ADDENDUM NO. 1

Renovate Sub (Acid) Lab Missouri Geological Survey (DNR) Rolla, Missouri

PROJECT NO.: W2001-01

**PLUMBING PLAN**

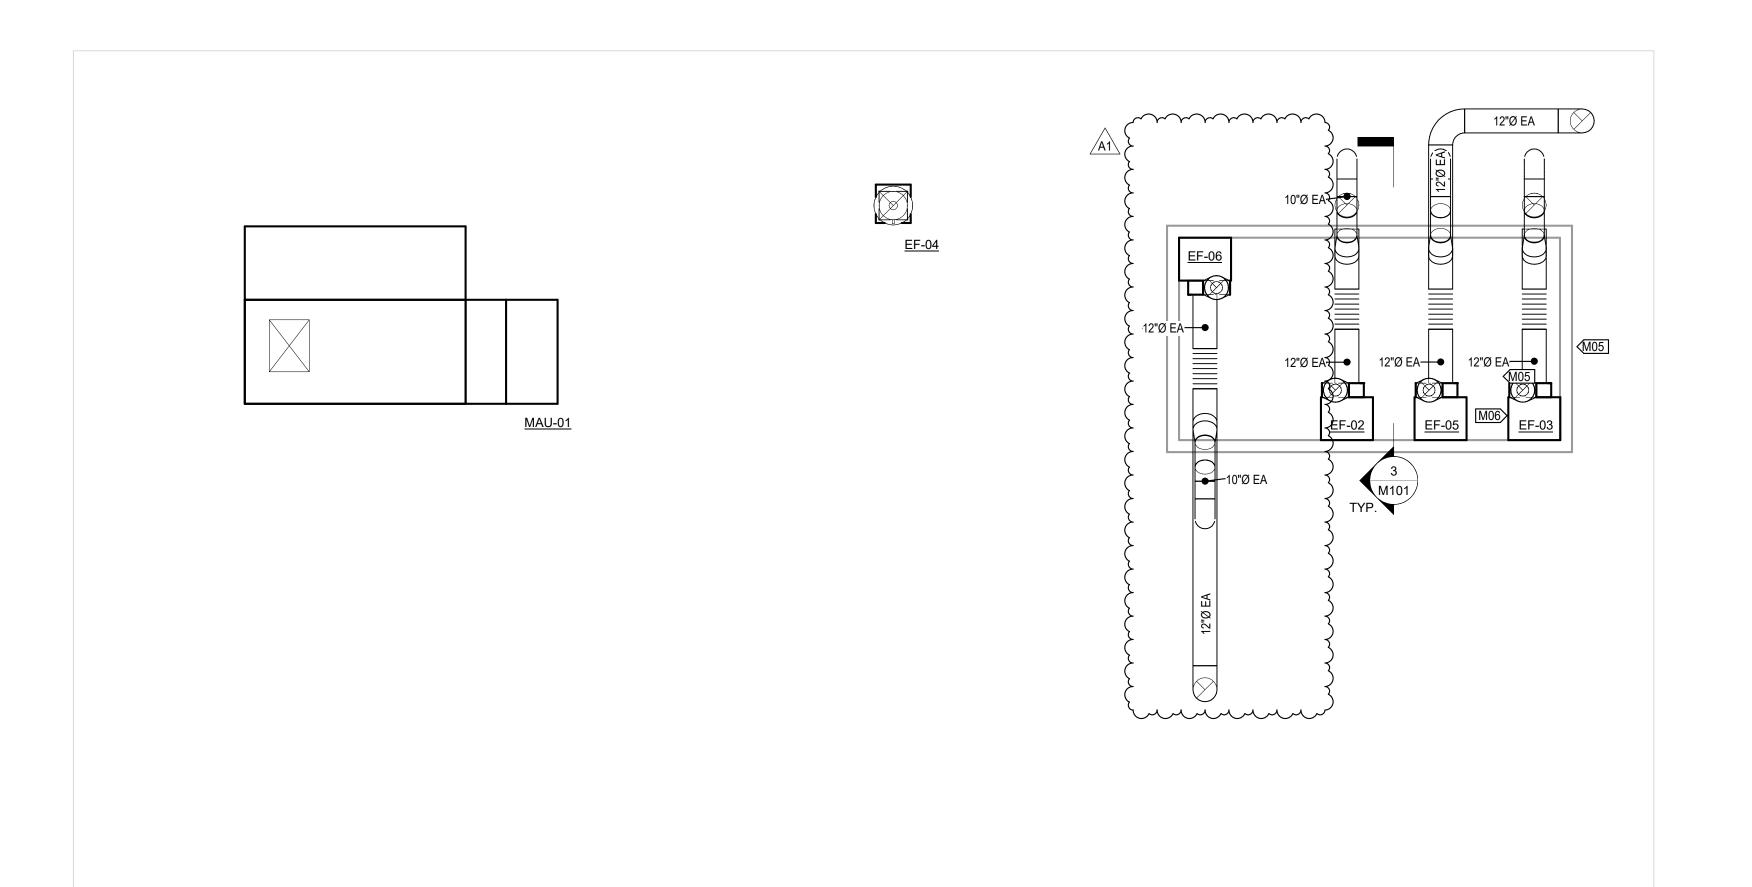
- a. REVISE location of lab sink from room 104 to room 107 and revise corresponding room names.
- b. REVISE plumbing plans for clarity.
- c. REPLACE section view with 3D-view.
- d. REVISE keyed notes with additional notes provided for additional detail.
- e. Revised sheet is attached.

**HVAC PLAN**

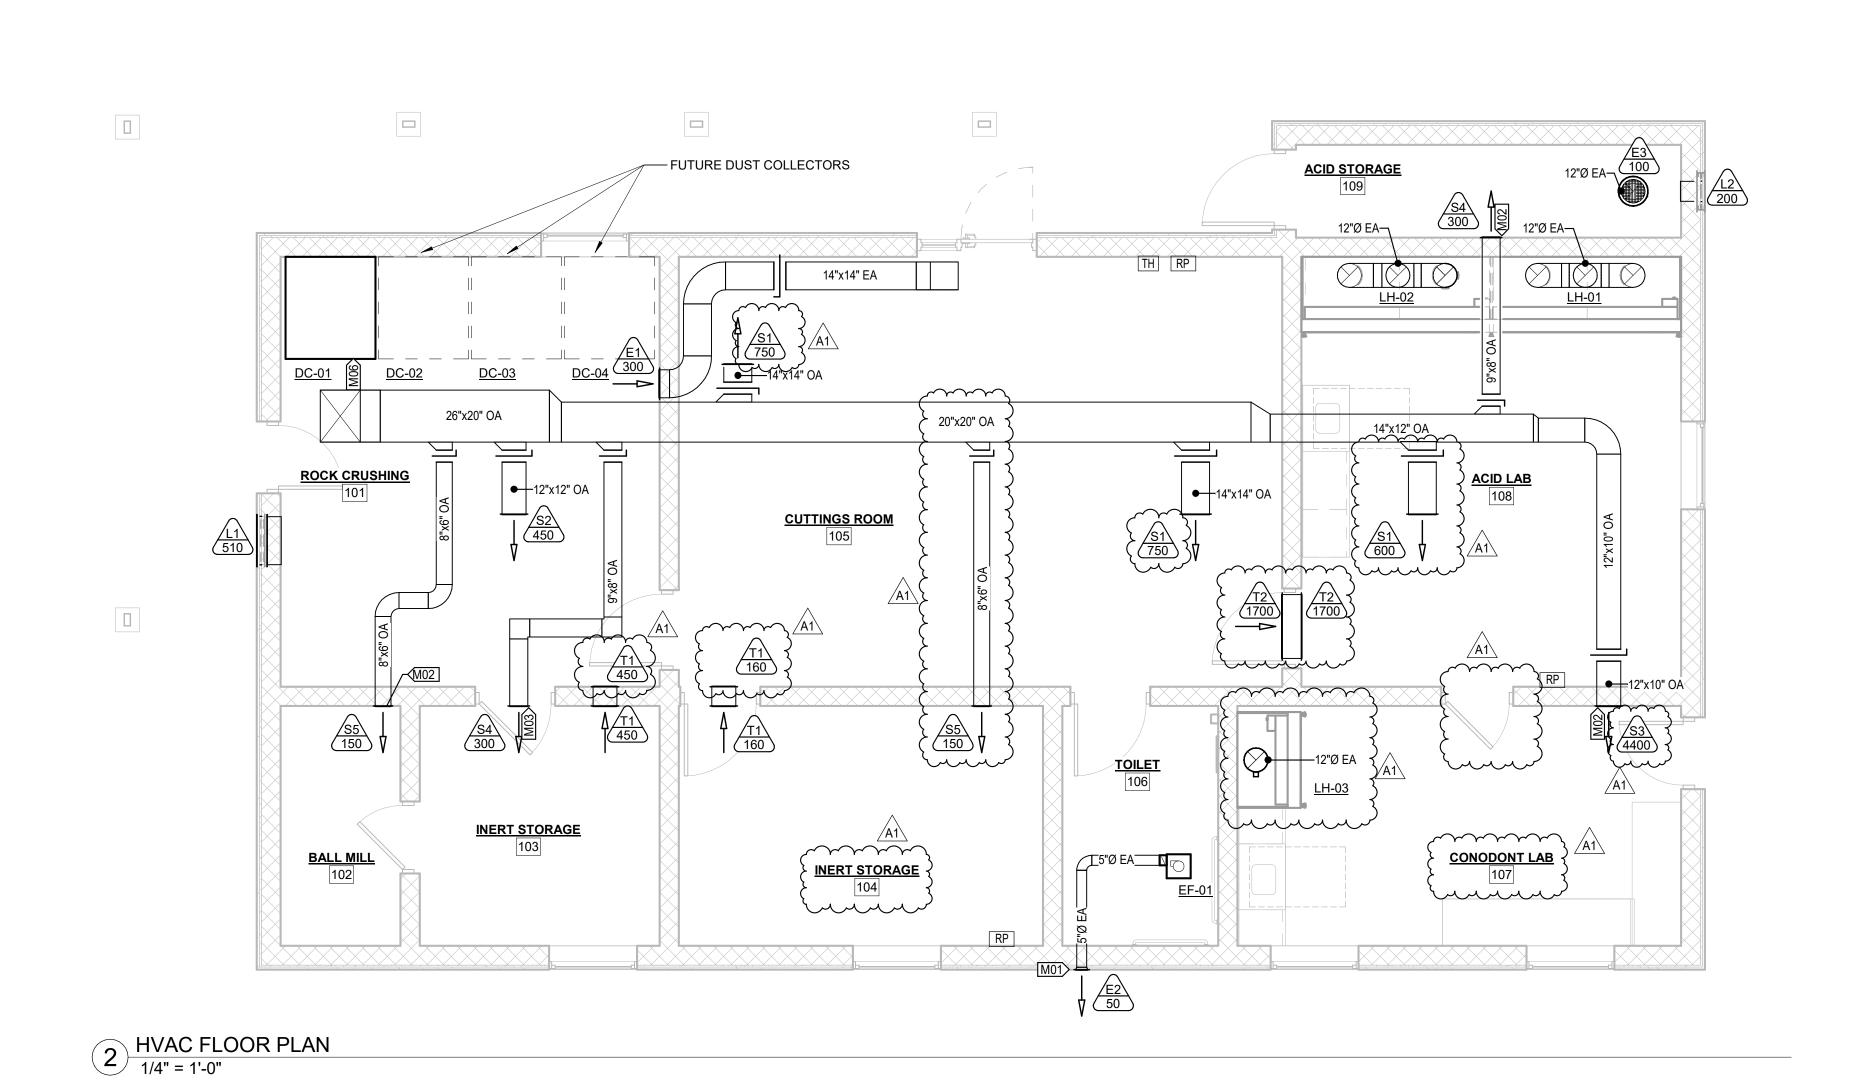
- a. REVISE location of EF-06 to accommodate revised lab hood location in room 107 in lieu of room 104. Revise corresponding room names.
- b. REVISE airflows from room 103, 104, 105 and 107.
- c. ADD transfer grilles.
- d. ADD supply air duct to room 104.
- e. ADD supply air duct to room 108.

- f. DELETE transfer duct between rooms 108 and 107.
- g. ADD PVC Exhaust Duct Notes to Detail 3.
- h. REVISE duct note to read PVC exhaust duct in lieu of schedule 40
- i. Revised sheet is attached.

CAD DWG FILE: M601 DRAWING BY: MHB CHECKED BY: JJN DESIGNED BY: MHB

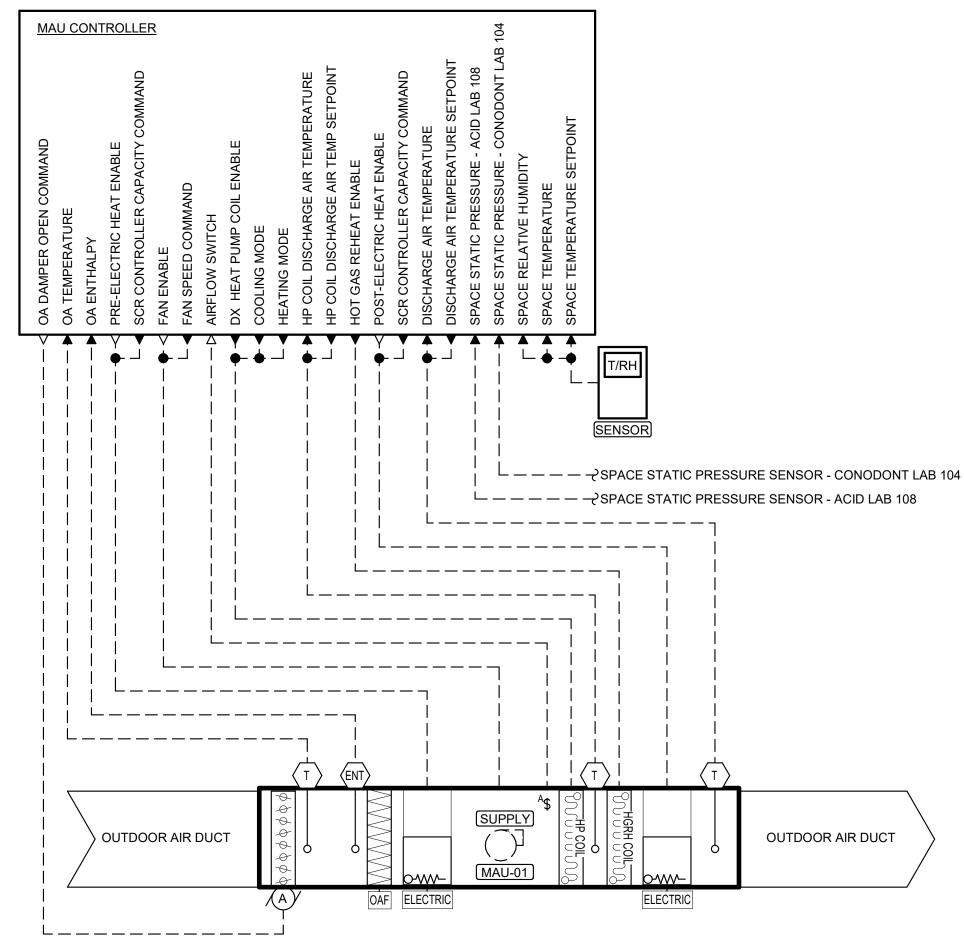
- a. REVISE Remarks on Exhaust Fan Schedule to note all fans shall be associated with the base bid.
- b. REVISE Exhaust Fan Schedule Basis of Design model number for the Labconco model to 7183413 for EF-02, EF-03, EF-05 and EF-06.
- c. REVISE Remark 2 below Exhaust Fan Schedule as follows: 3-speed fan control provided by lab hood controller.
- d. Revised sheet is attached.

ELECTRICAL SITE PLAN

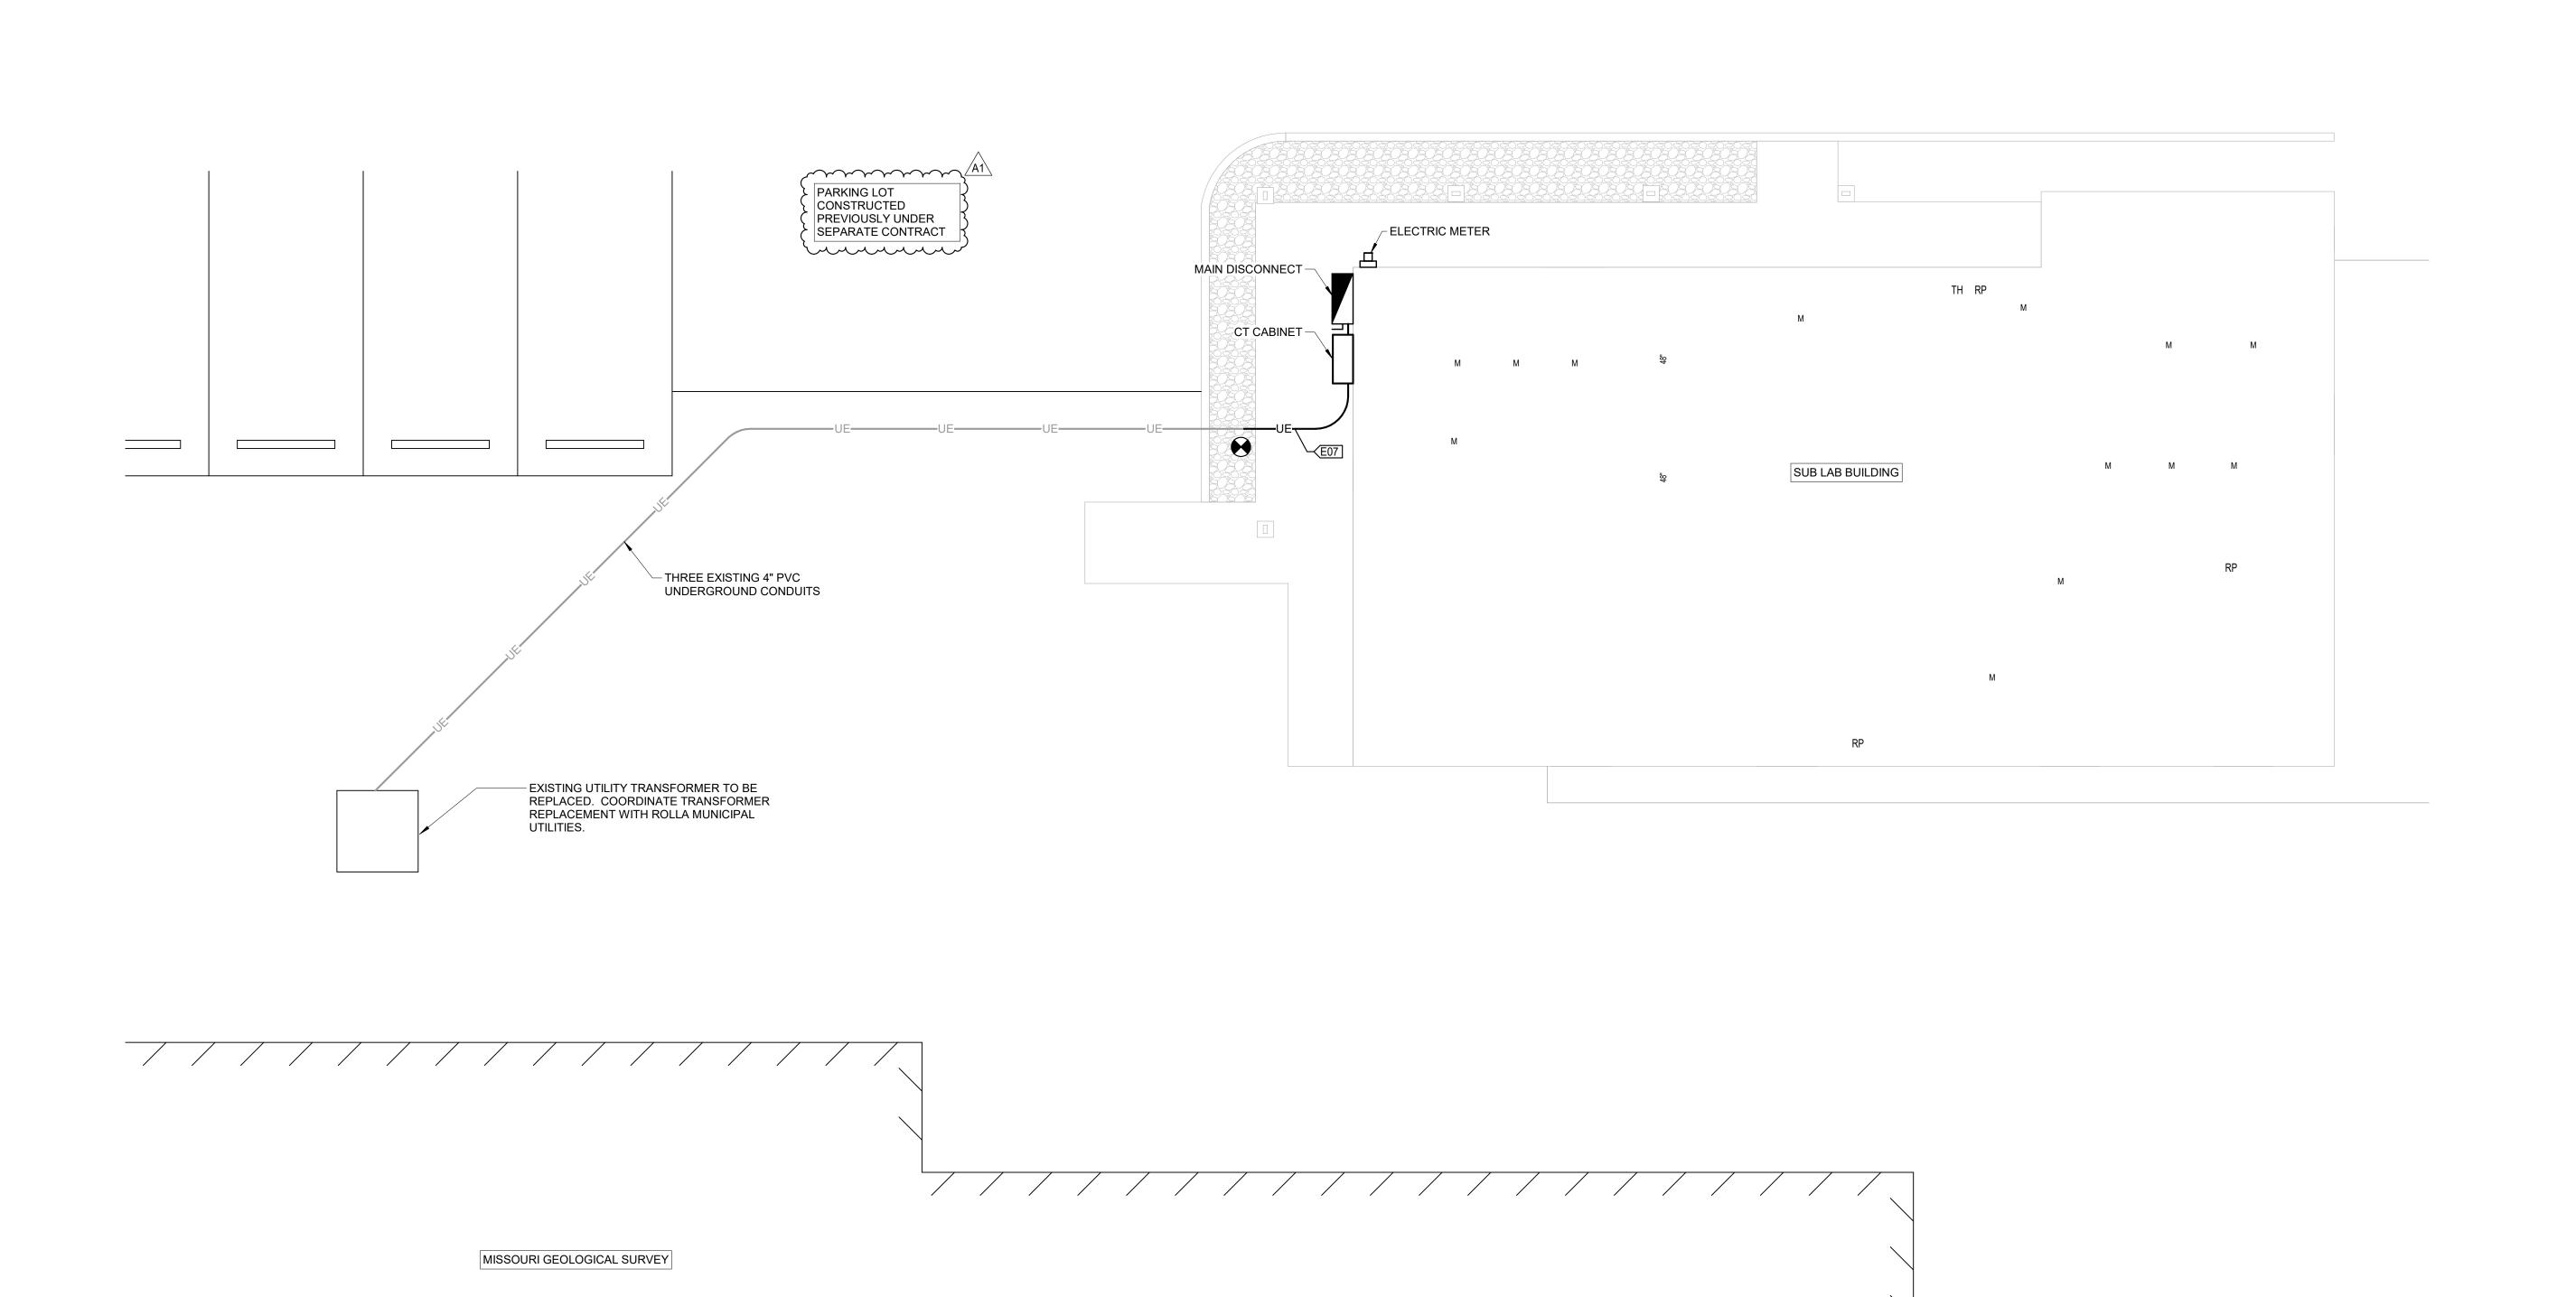
- a. REVISE Label on parking lot from "New Parking Lot" to be "Parking Lot."
- b. Revised sheet is attached.

**POWER PLAN**

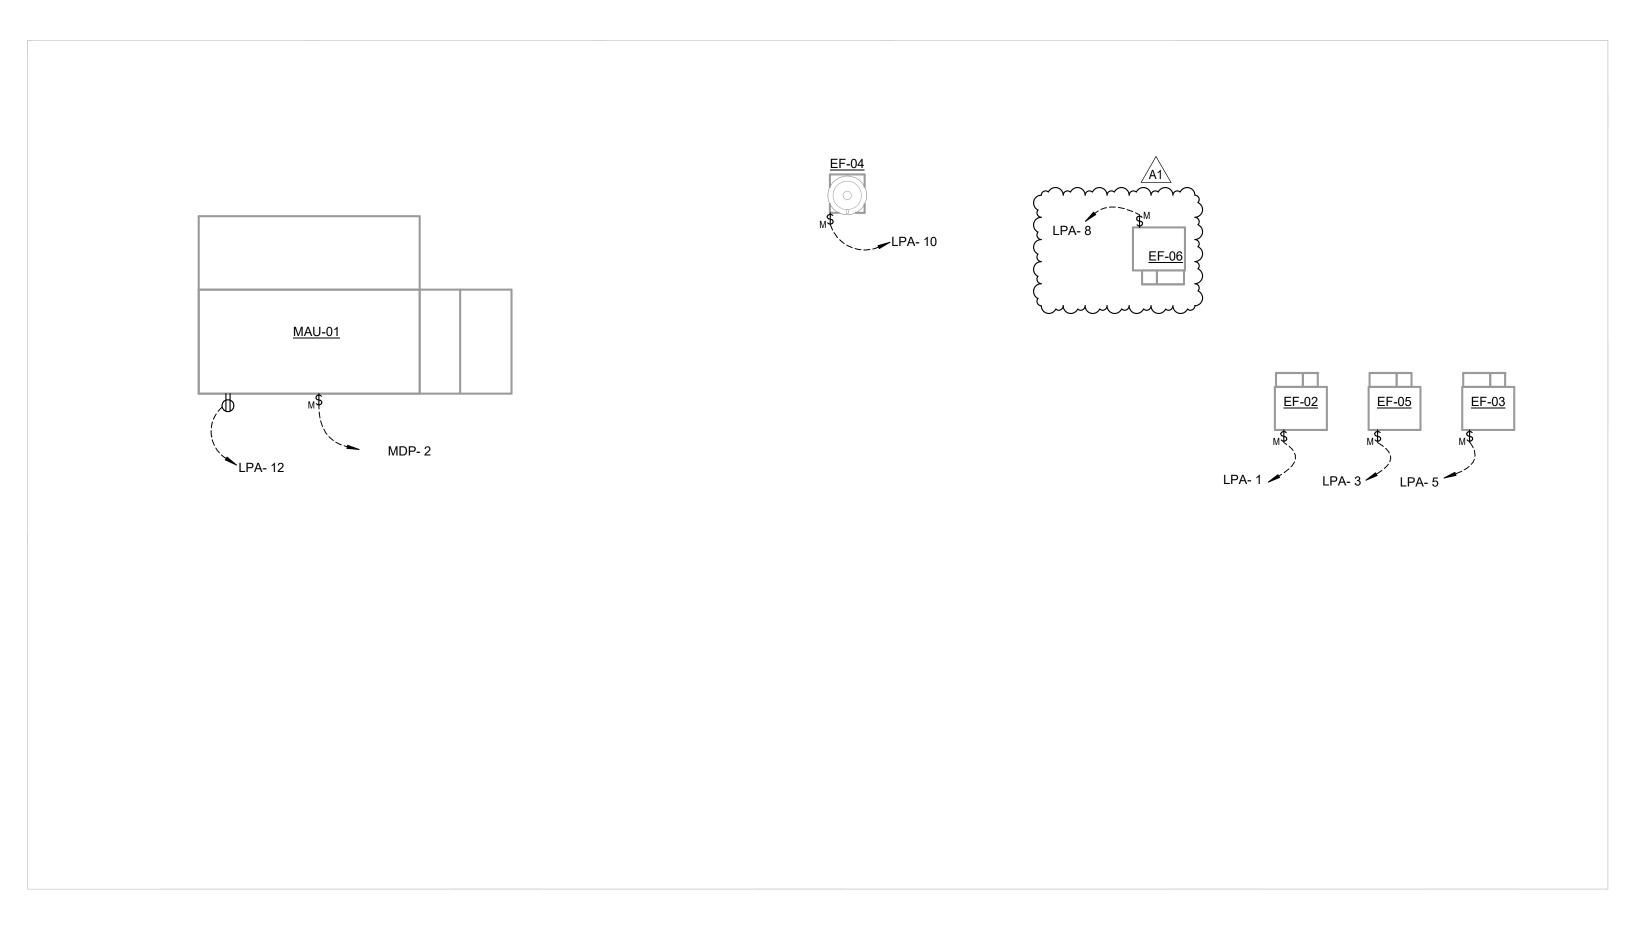
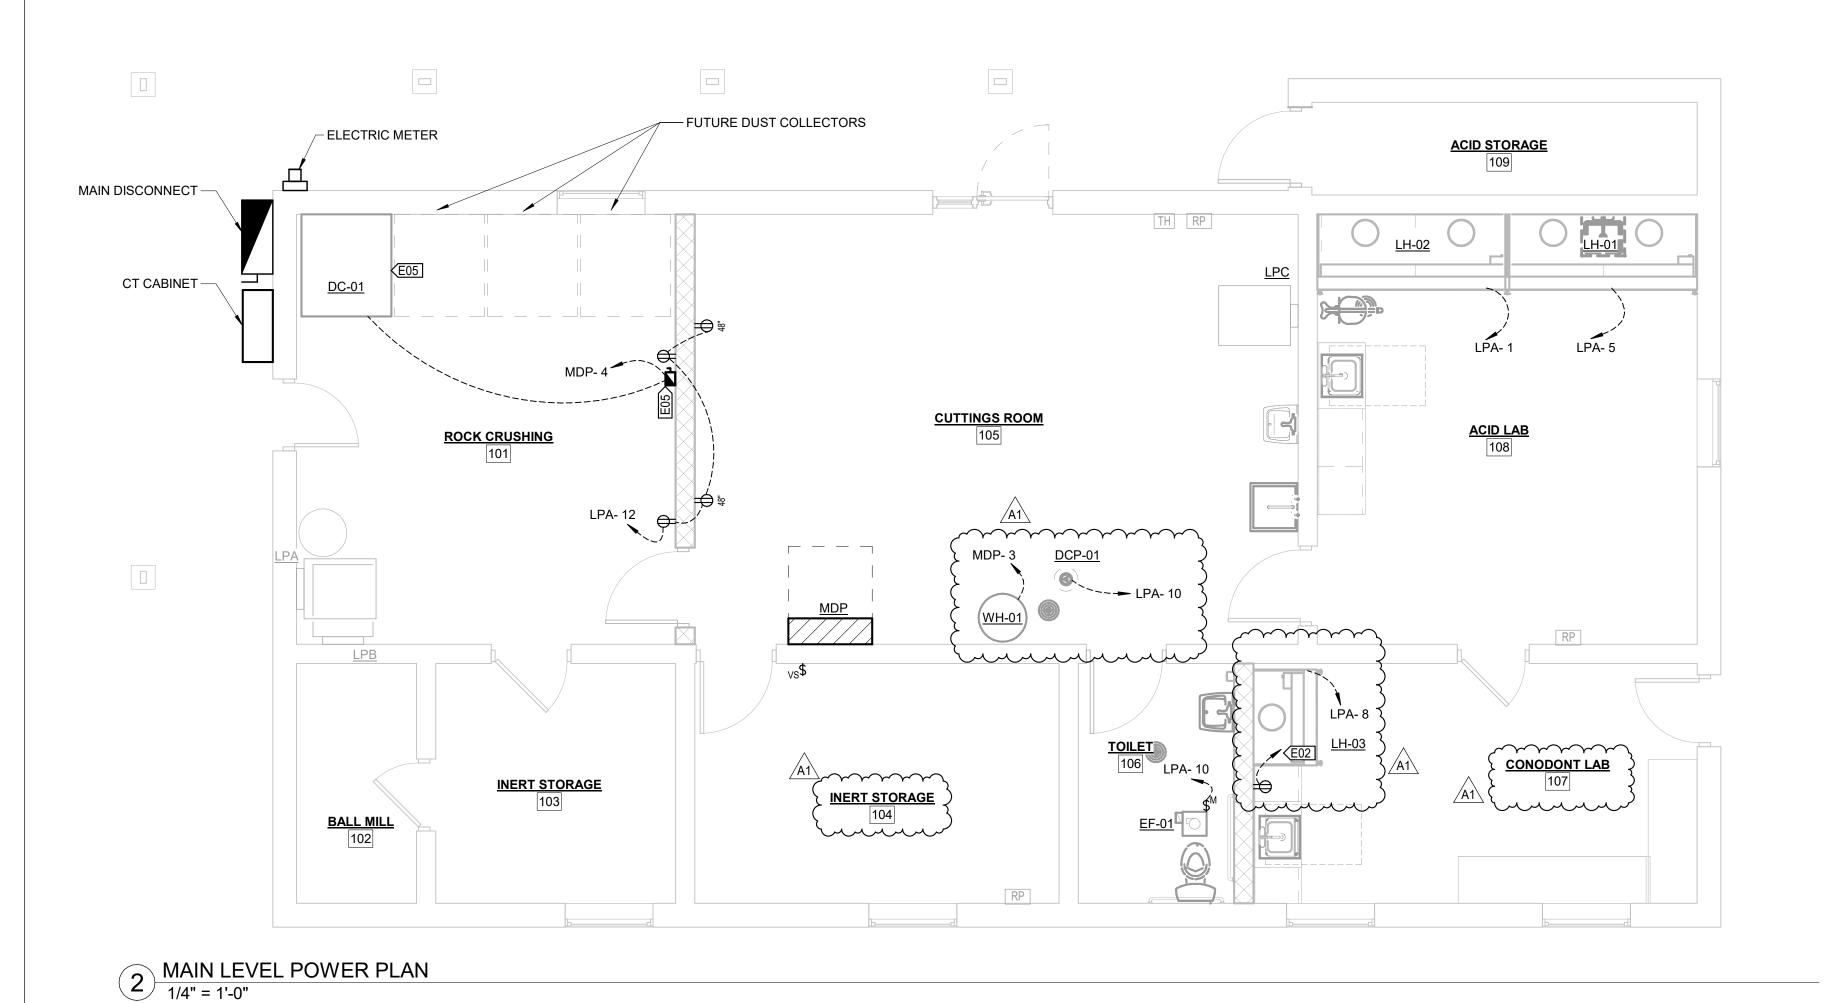
- a. REVISE location of EF-06.
- b. REVISE location of water heater and circulation pump.
- c. REVISE room names for rooms 104 and 107.
- d. REVISE location of lab hood LH-03.
- e. Revised sheet is attached.
